APPEAL SUMMARY

Status: Decision Rendered - Reconsideration of ID 22255

Appeal ID: 23417	Project Address: 1528, 1530, 1534, 1536 N Blandena St
Hearing Date: 2/5/20	Appellant Name: Paul Wolfe
Case No.: B-011	Appellant Phone: 5039543065
Appeal Type: Building	Plans Examiner/Inspector: Geoffrey Harker
Project Type: commercial	Stories: 4 Occupancy: R-1 Construction Type: V-A
Building/Business Name: Homestead at Pittman Park Hotel	Fire Sprinklers: Yes - NFPA 13 Throughout
Appeal Involves: Reconsideration of appeal, occ Change from R-2 to R-1	LUR or Permit Application No.: 19-122517-CO
Plan Submitted Option: pdf [File 1]	Proposed use: Transient Dwelling (Hotel/Motel)

Homestead at Pittman Park Hotel
1518 N Blandena Street, Portland, OR 97217

1
A-2 Proposed Ground Floor Plan
Scale: 3/32" = 1'-0"

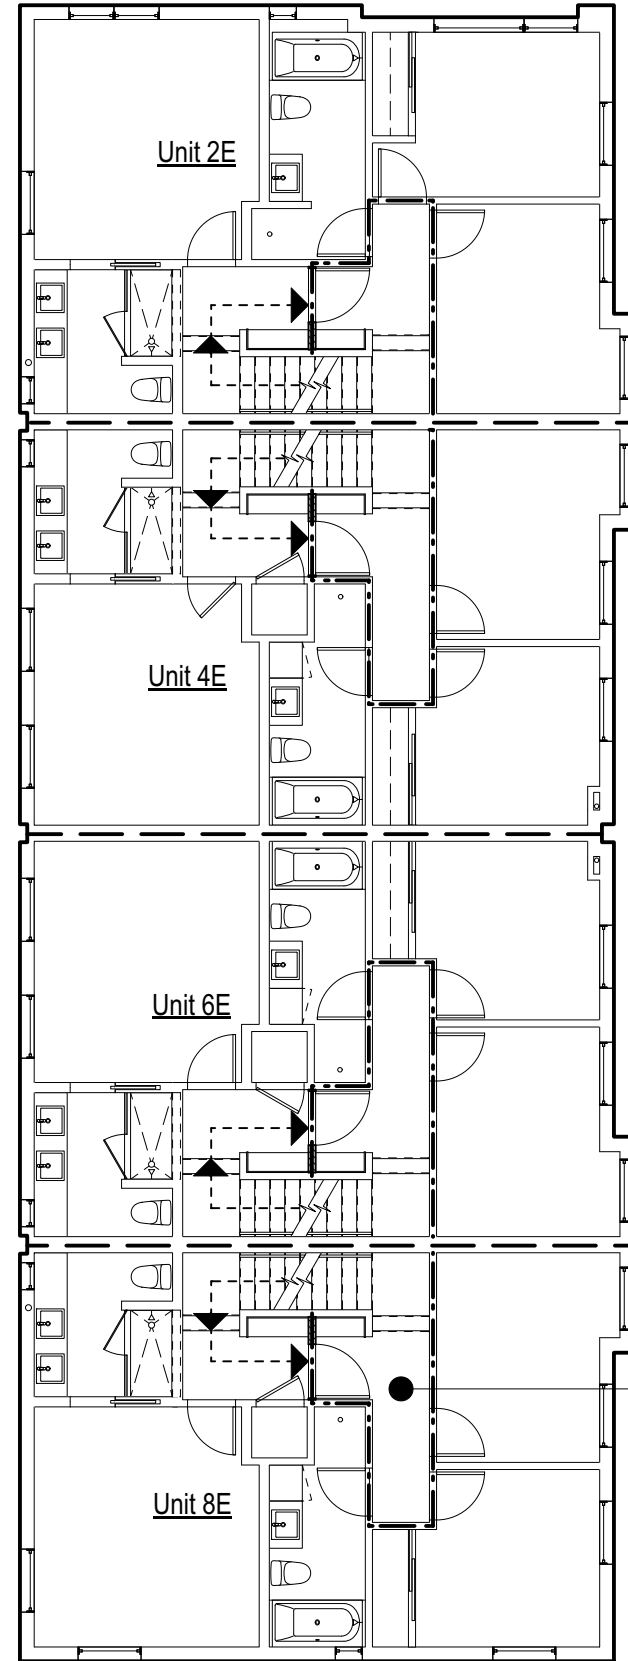
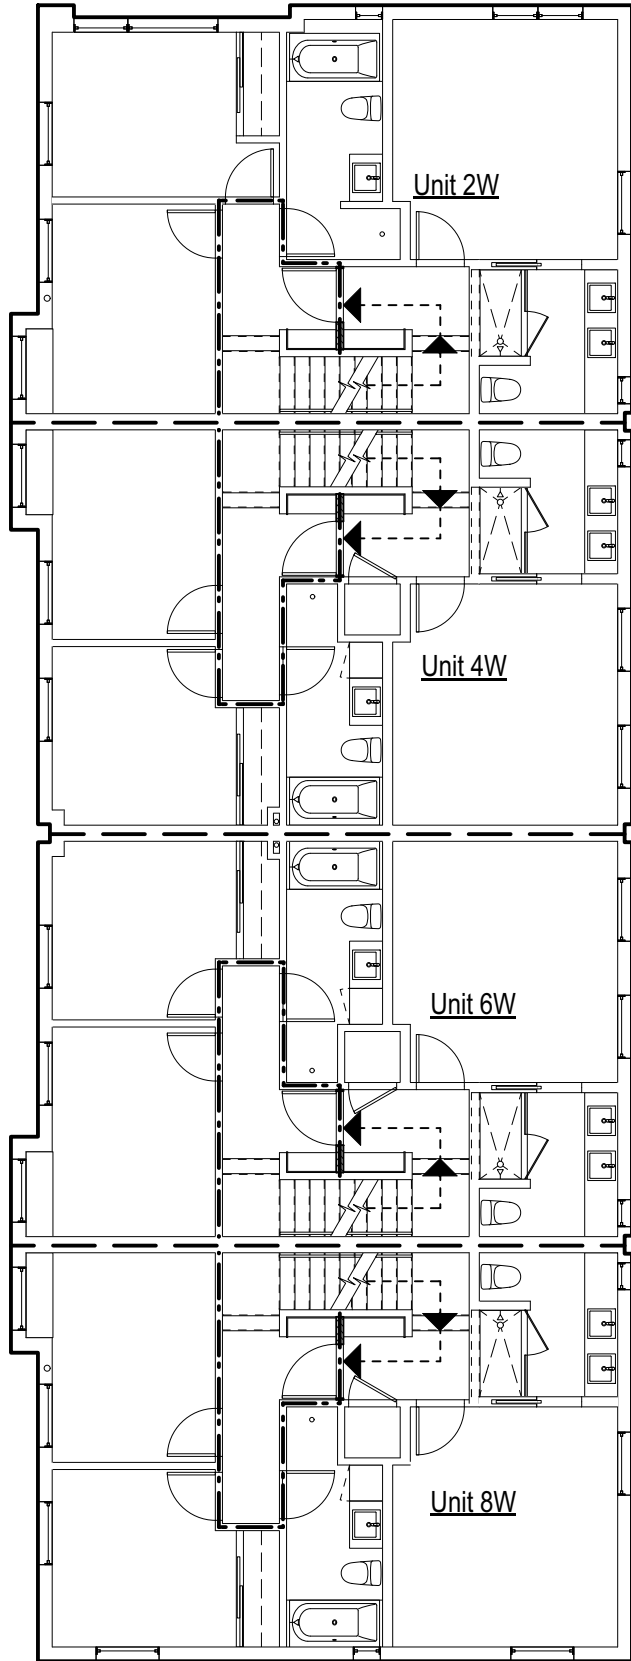
Proposed project configuration is a 2-building, 4-story 16 unit R-1 motel permitted under the commercial code (2019 OSSC). The garage + bonus room of each existing unit (8x) will be converted to a separate 1-bedroom R-1 unit. New kitchens, bathroom modifications, and reconfiguration of interior partitions will accommodate the new units.

Second Exit for 4-story unit

New 1-hr horizontal separation;
Typ. at ea. new ground floor unit

Existing/Proposed Second Floor Plan
Scale: 3/32" = 1'-0"

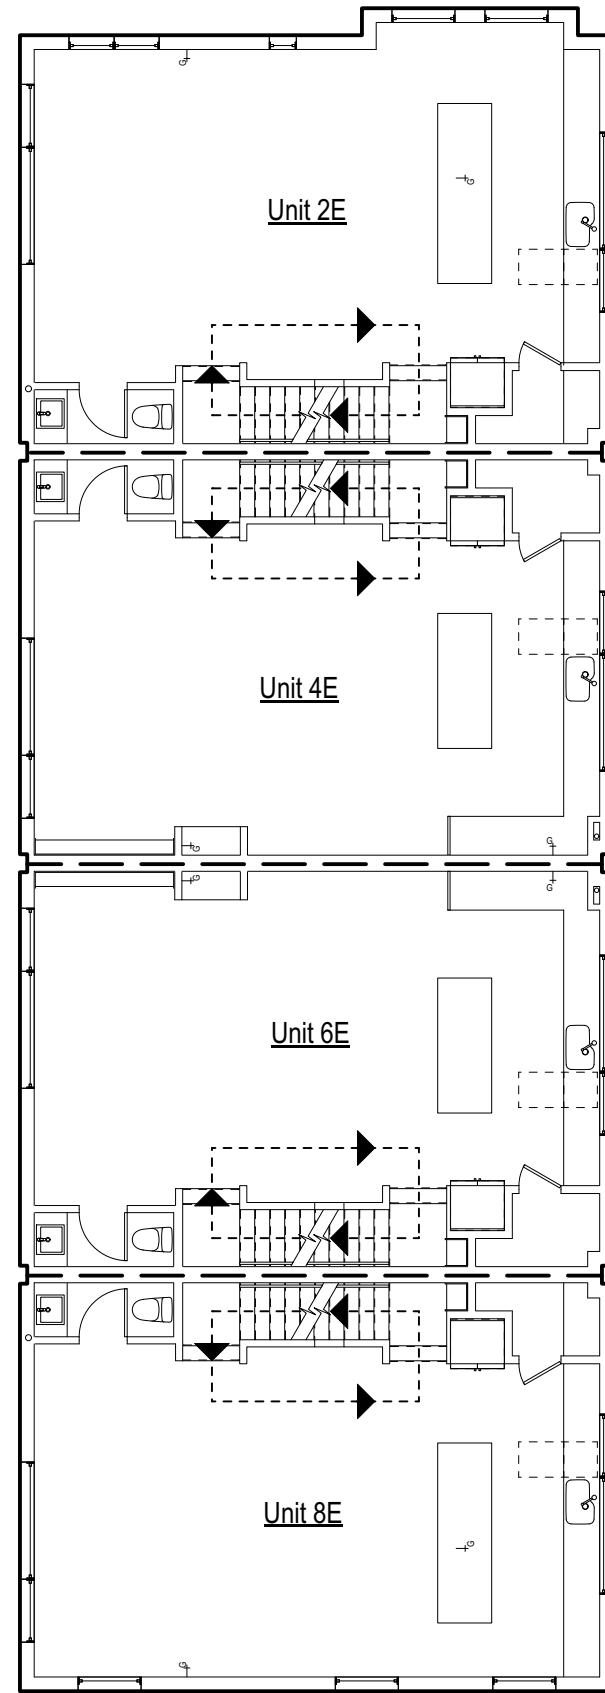
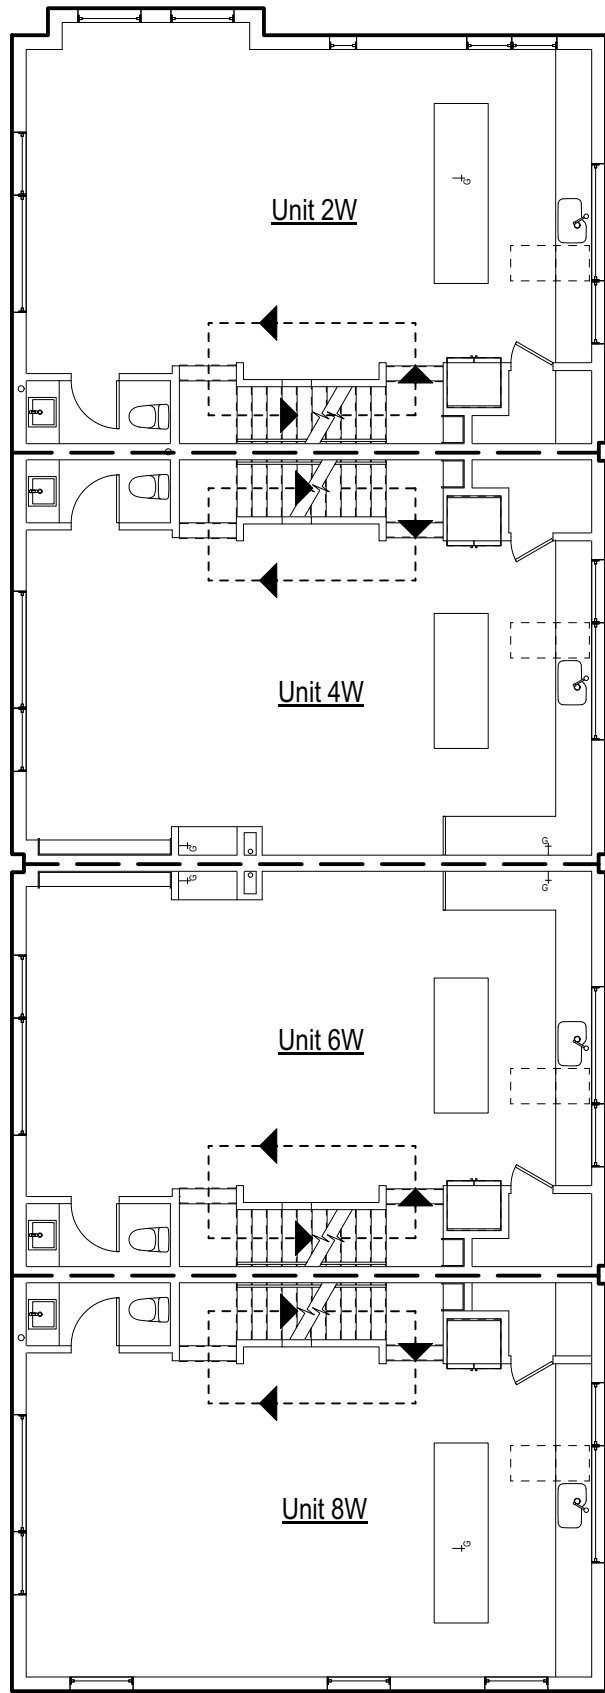
New 1-hr rated stair enclosure from the mid-point of the second floor down to the ground floor exits.

New 1-hr rated exit stair enclosure; typ. to ground floor

Increase in maximum allowable exit access travel distance in all 4 units: Granted provided a monitored alarm system is installed that includes smoke detection in the stairs at the 1st and 2nd levels and 1 notification device in the stairs at levels 1, 2, 3 and 4 and provided no bathroom opens into the stair enclosure, and provided there is no storage in stair enclosure and provided space below stairs is not

1 Enlarged Typical Unit Floor Plans
A-6 Scale: 3/32" = 1'-0"

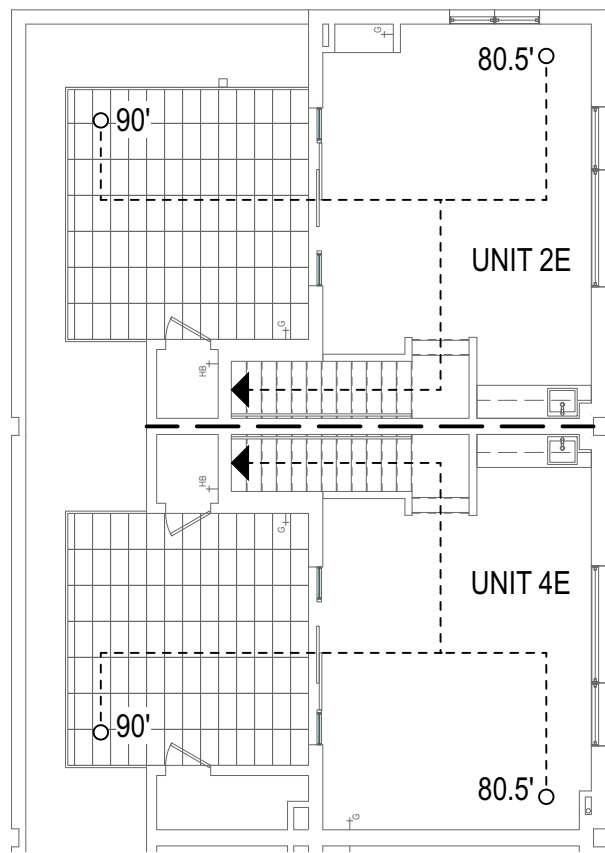
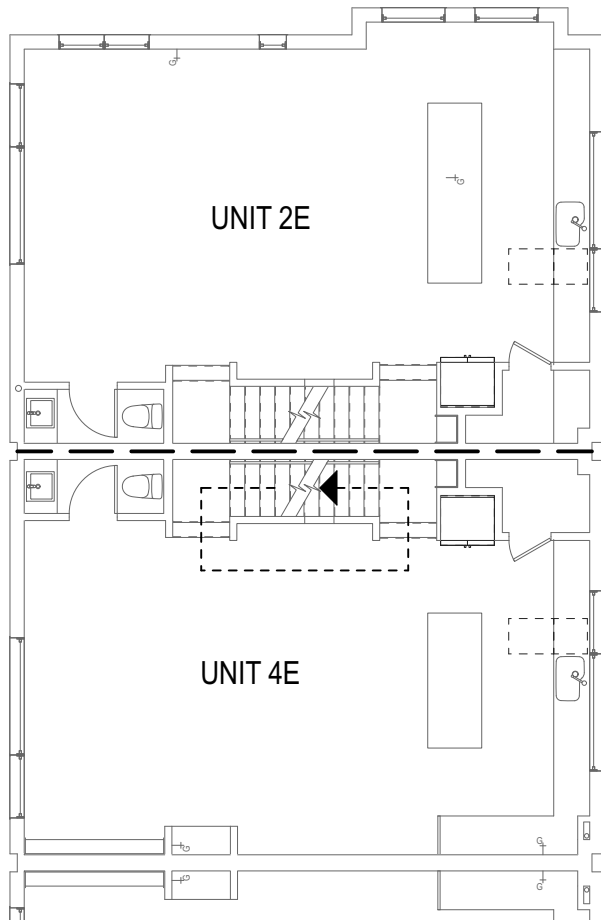
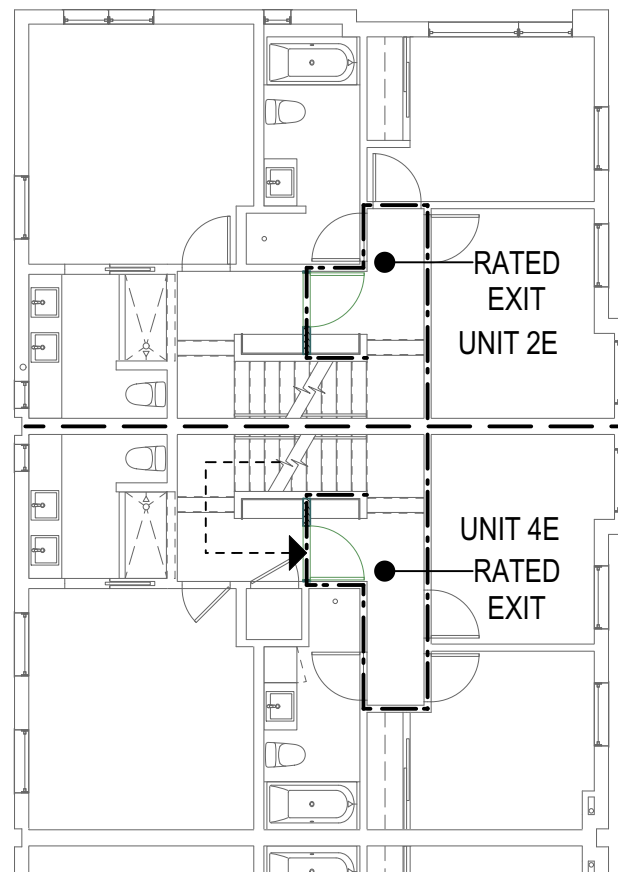
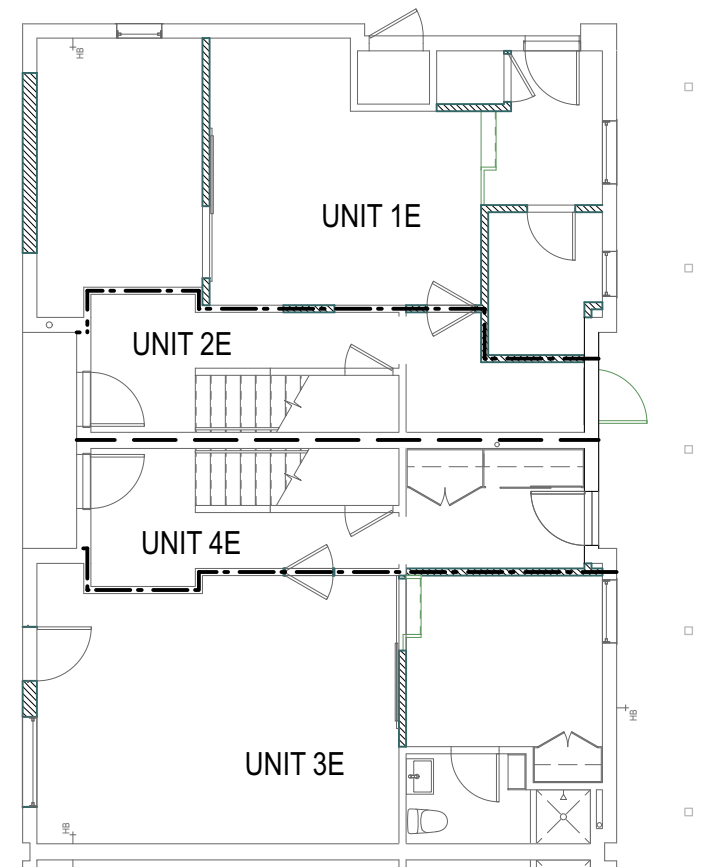
Travel distance shown from points denoted by circle icon.

- Max Travel Distance - 90' @ Building A (shown)
- 90'-10" @ Building B

- Existing Stair to be 1-hr rated from mid-second floor down to exterior exit doors on ground floor. The newly rated stair will have a door on a magnetic hold-open tied to the fire sprinkler system on the second floor.
- Upgrades will be made to existing doors and walls/ceilings to ensure full 1-hr rating.
- No change to (E) 2-hr demising walls

- 2 ground floor Exits from 4-story R-1 units.
- Communicating Hotel-style rated doors between 4-story and 1-story units; doors to facilitate multi-unit rental - locked from ea. side.
